JUSTIFICATION

RE-USE OF ATTIC FLOORBOARDS

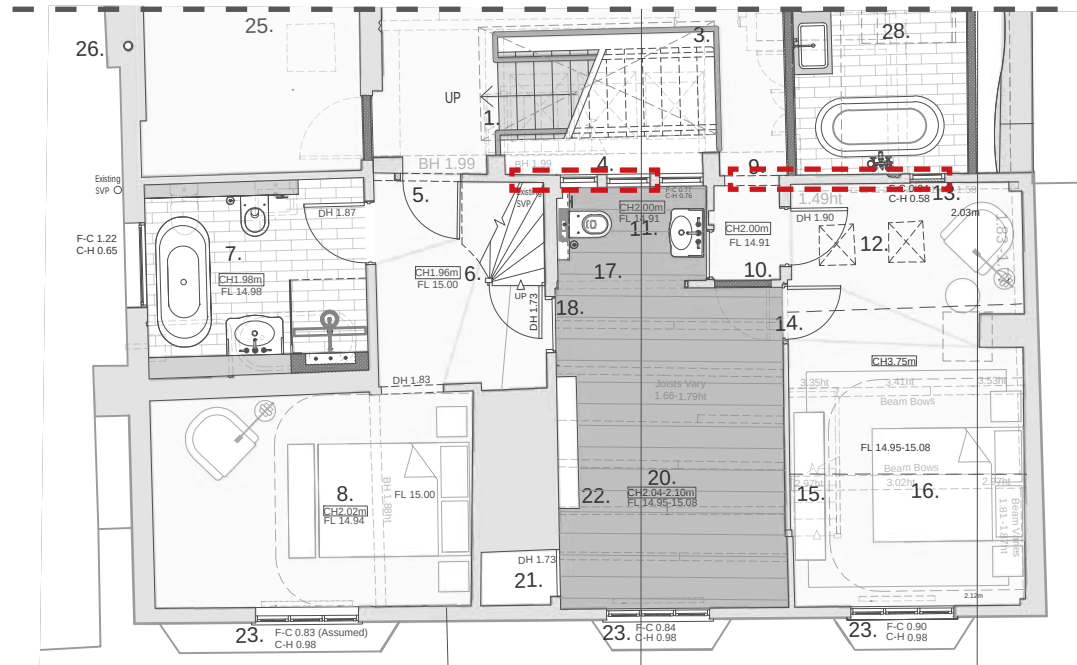
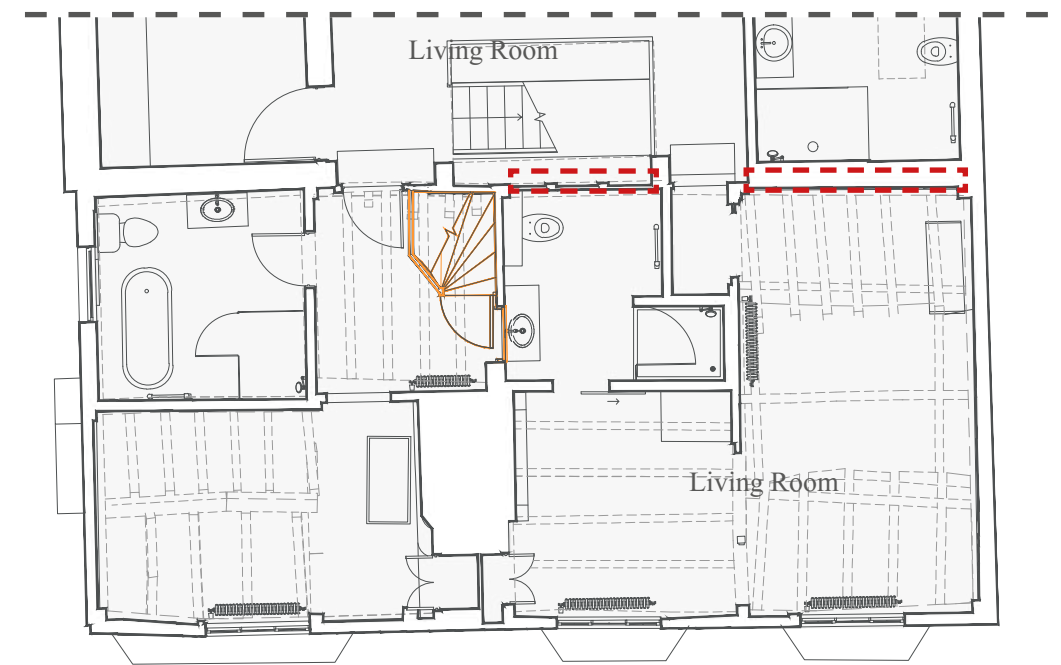
The casement windows to the west facade of the listed building have been removed and openings filled in, deviating from the approved scheme proposing their retention.

The windows were not original, added in 1990s and poorly detailed. After their removal the openings have been infilled with traditional fibrous wood wool boards faced in lime plaster. This change reveals and expressed the 15th century timber framing, which has been carefully repaired and renovated, which according to the supporting HCUK report is a significant heritage benefit.

4. Proposed first floor plan

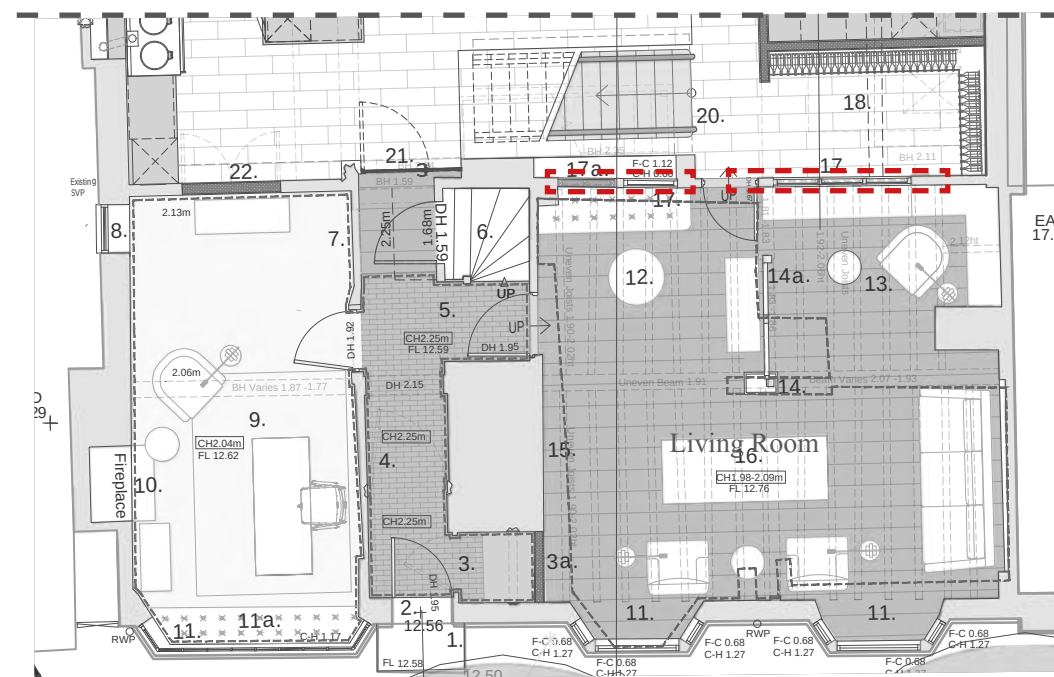
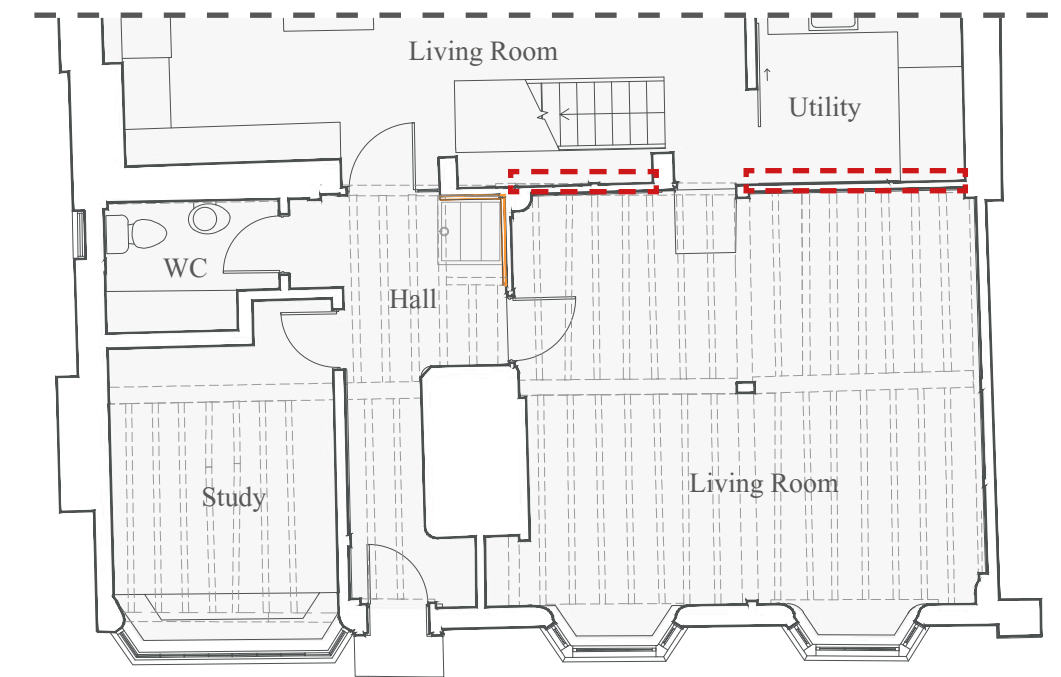
Three number of ground floor new doors have been constructed by re-using space floorboards found in the attic. The doors have been finished in a manner to compliment the character of the listed building. These are annotated with numbers on the adjacent drawing and illustrated with recent photographs.

Mainly on the first floor, new doors have been made of the same oak panels used for overlaid flooring. These doors are marked with ‘*’ on the adjacent drawings. Doors marked with ‘E’ are existing timber doors.

4. Proposed rear elevation.

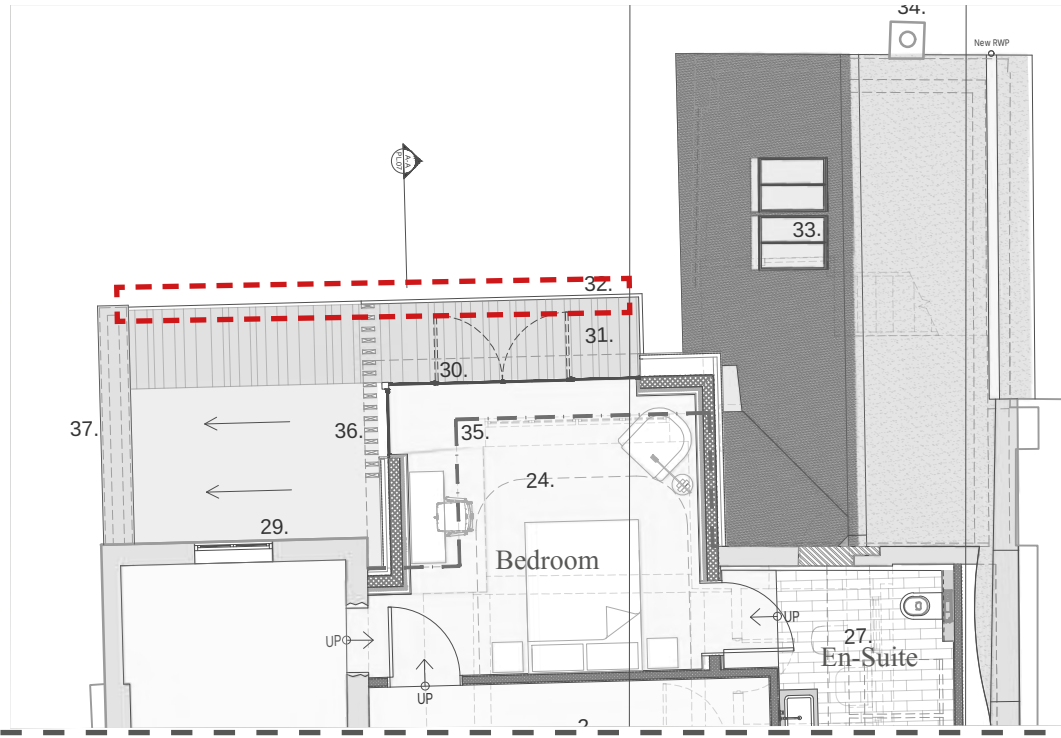
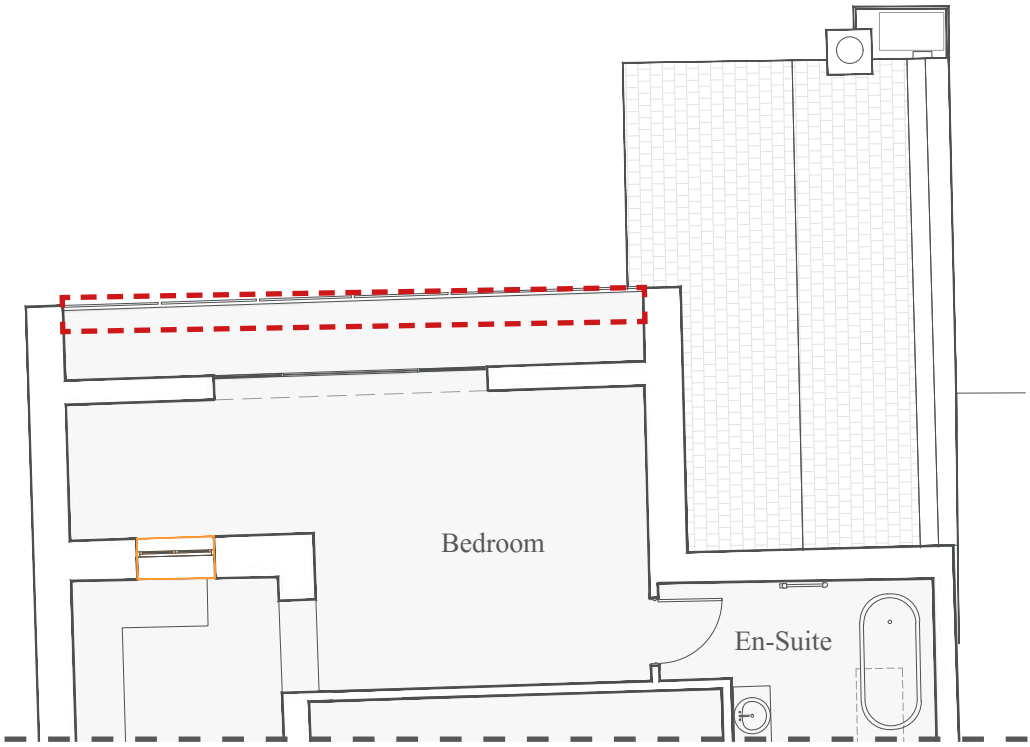
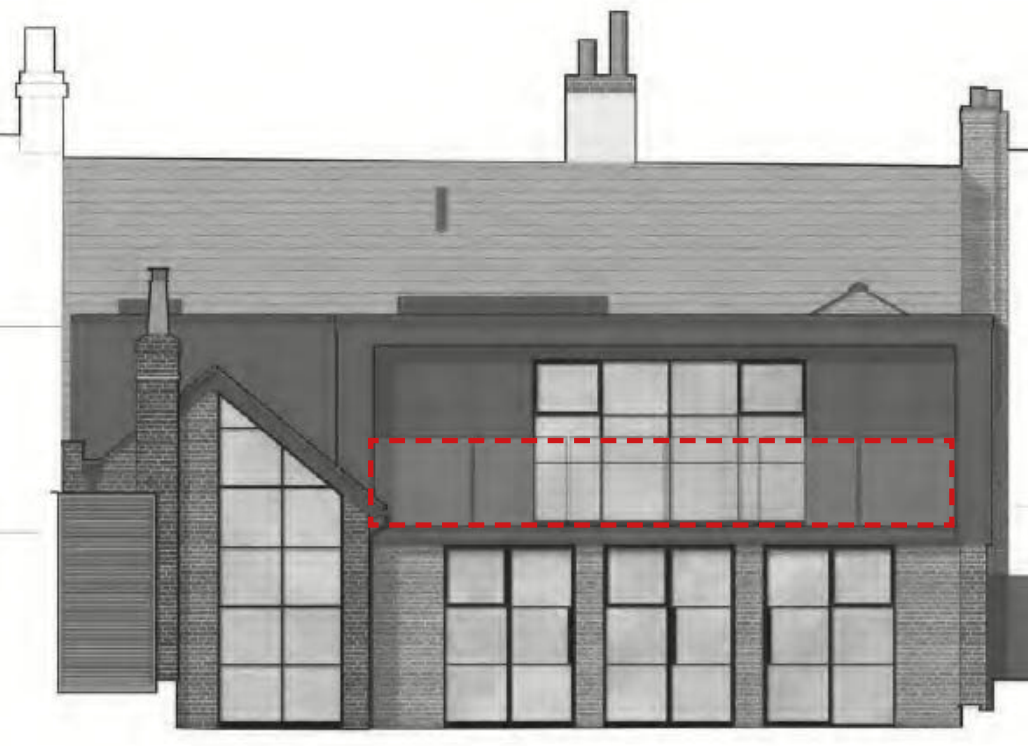
The constructed balustrade to the rear elevation is a deviation
The balustrade to rear terrace has been constructed in deviation to the approved scheme. Due to the increased width of the ‘as-built’ extension the current balustrade has more length. Its design has been changed from metal rail with balusters to a frameless glazing system.

The change to a frameless glazing system is more discreet and visually seamless, reducing the visual obstruction of the overall appearance of the facade, creating less distraction and visual clutter. According to the supporting HCUK Heritage Statement, it is considered to have neutral impact on the significance of the listed building.

As noted previously, the approved drawings of application DM/22/3694 & DM/22/3695 are not consistent. The balustrade appears to span full length of the rear extension on the plan, which is what was implemented.

Proposed ground floor plan

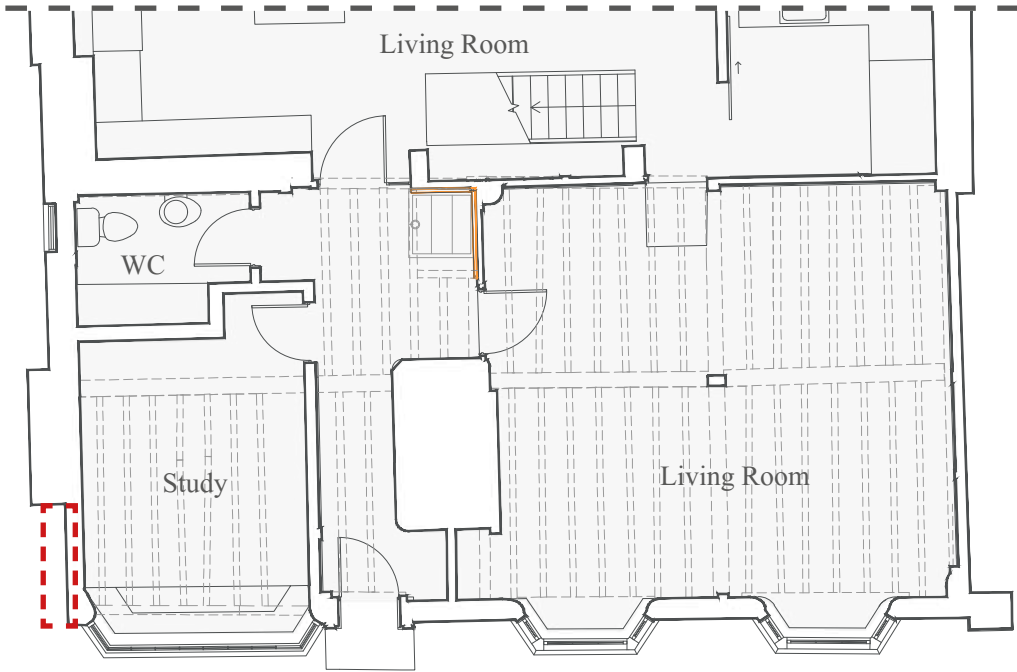
It was approved for the existing timber weatherboarding to the return corner of the front (East) and side (South) elevation to be extended down to ground level.

Leaving it as it is retains the legibility of a possibly truncated timber jetty as well as the exposed timber framing and brick nogging to this return elevation. Under-implementation of this change is preferable in heritage terms.

Proposed Scheme
Section BB

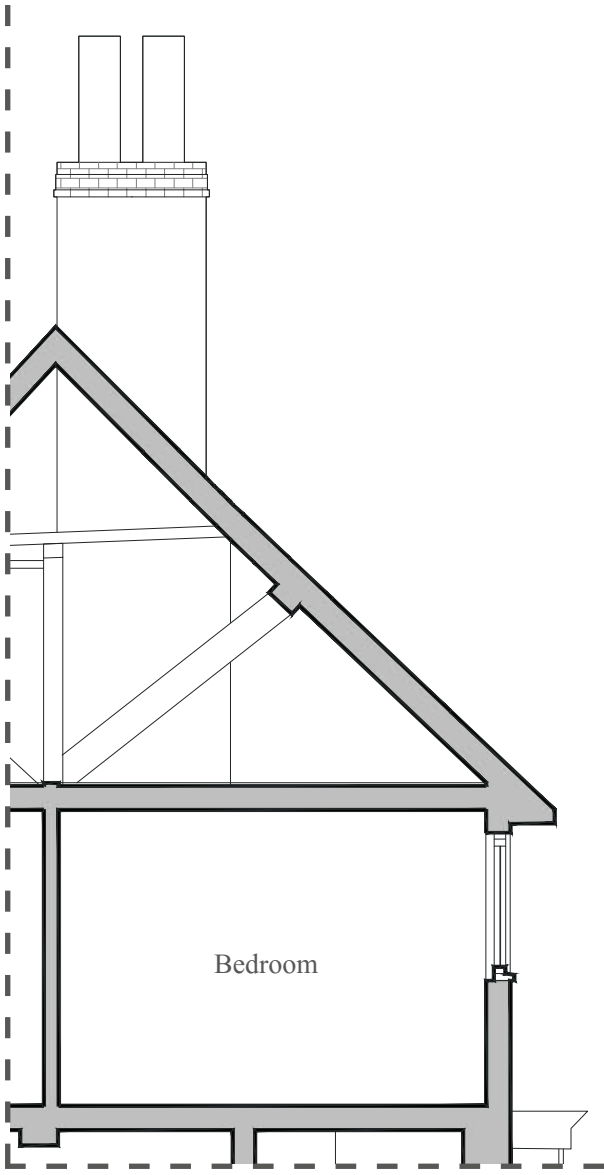
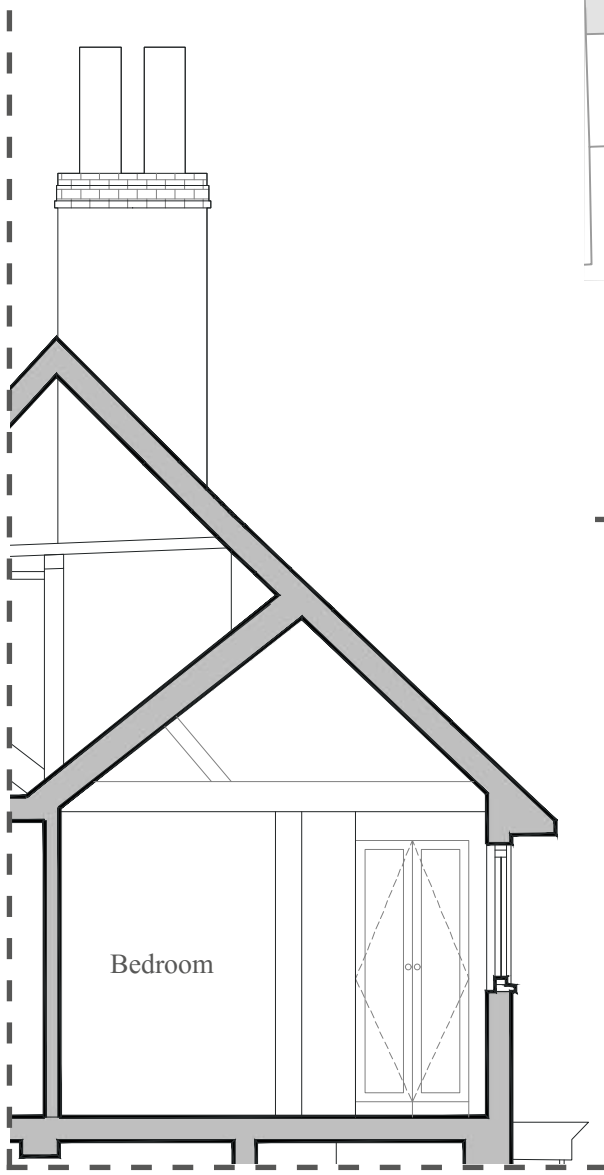
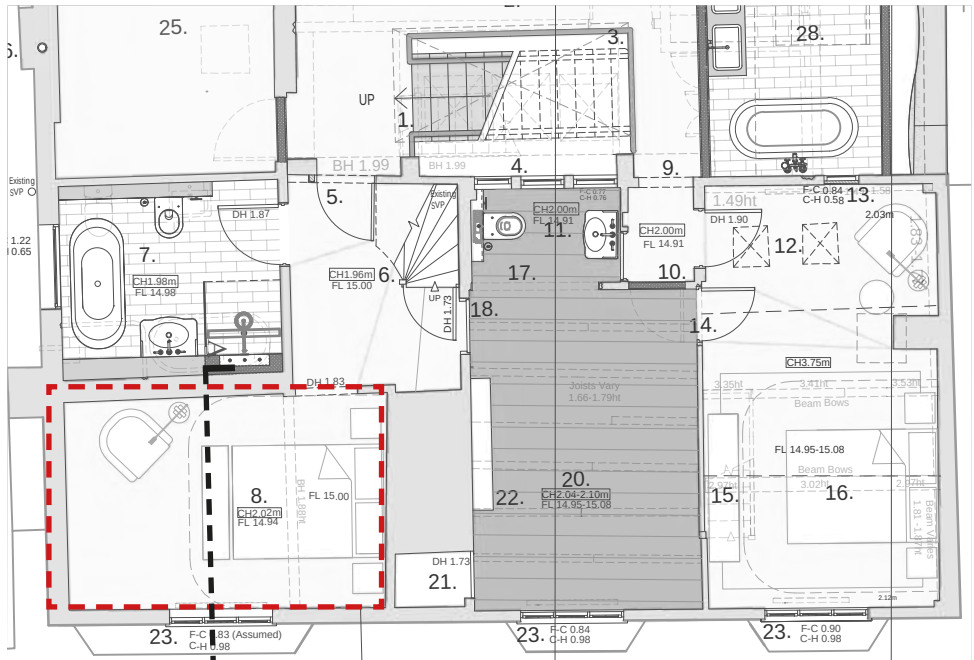
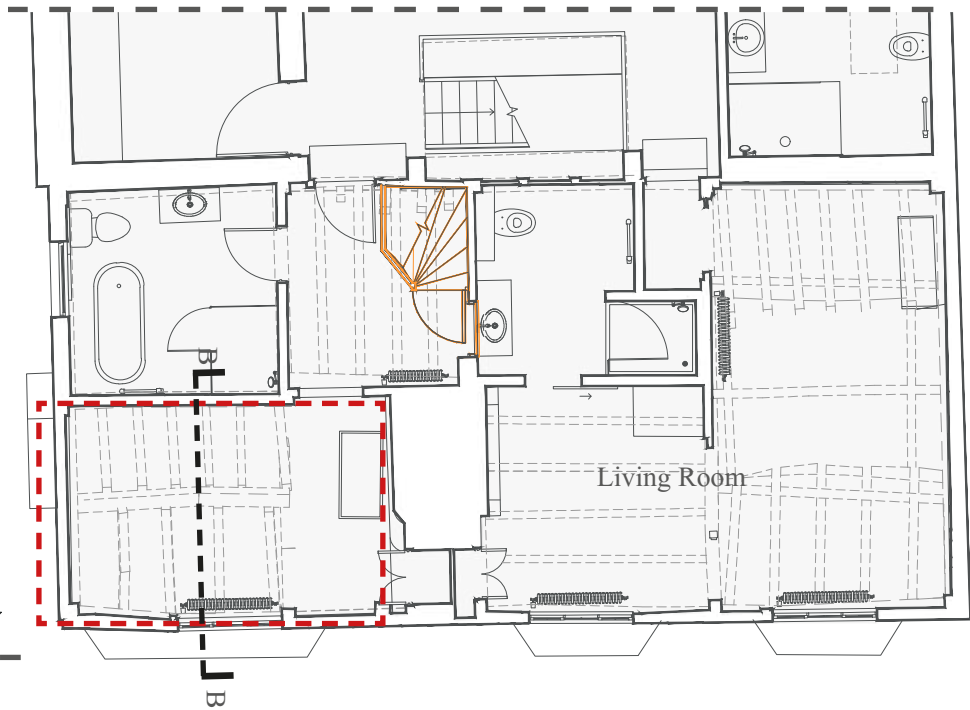
The approved documents and drawings contain conflicting information relating to this aspect of the scheme; this is confirmed on point 27 on drawing GH342 PL 07 B, but not clearly shown on the drawn content.

The modern ceiling build up with timber joists and gypsum plasterboard finish have been removed in the SE bedroom, with the creation of a vaulted ceiling. This has been created utilising reclaimed timber oak timber rafters with lime plaster infill. It is proposed to retain these works.

According tot the supporting HCUK heritage statement, this change has an ostensibly neutral impact on the listed building’s significance but is undoubtedly an improvement on the approved scheme which reinforces historic character and quality of the bedroom space.

Proposed ground floor plan

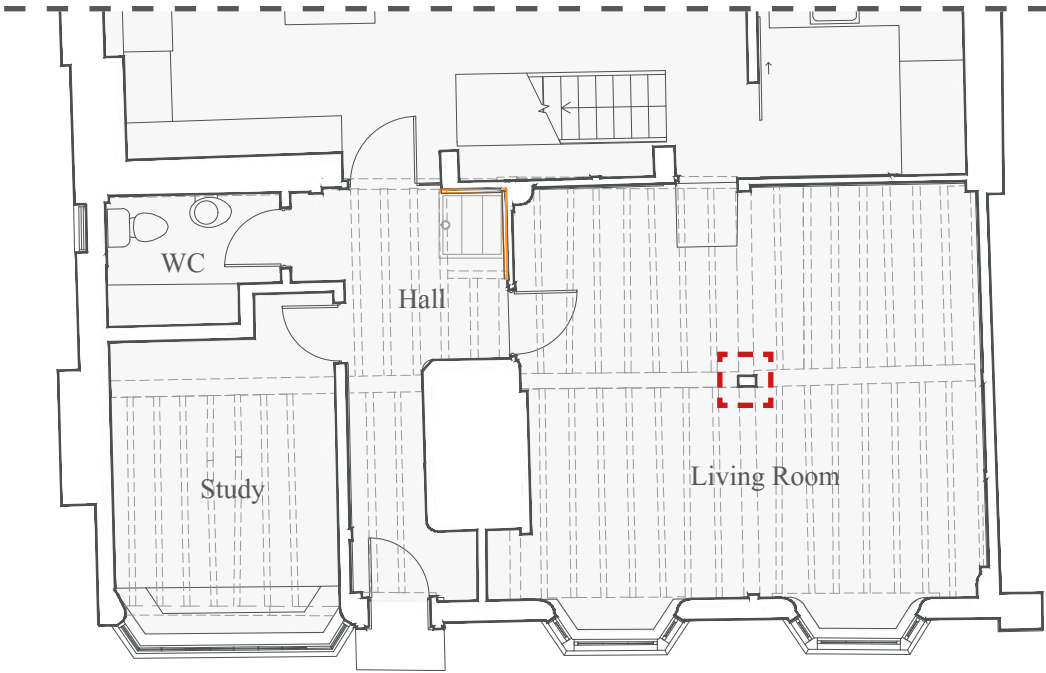
The replacement of the steel post propping the building’s timber frame has been approved at planning. This has been implemented and the steel post was replaced with a traditional gunstock post in seasoned oak. HCUK Heritage Report notes that:

‘this intervention represents a significant improvement on the improvised steel post and Acro-prop arrangement which it replaced. The Oak post is of a traditional design, with tapering ‘gunstock’ jowls. It is a credible and archaeologically accurate form of repair which nonetheless reads as honest and new.’

This repair is of clear heritage benefit.
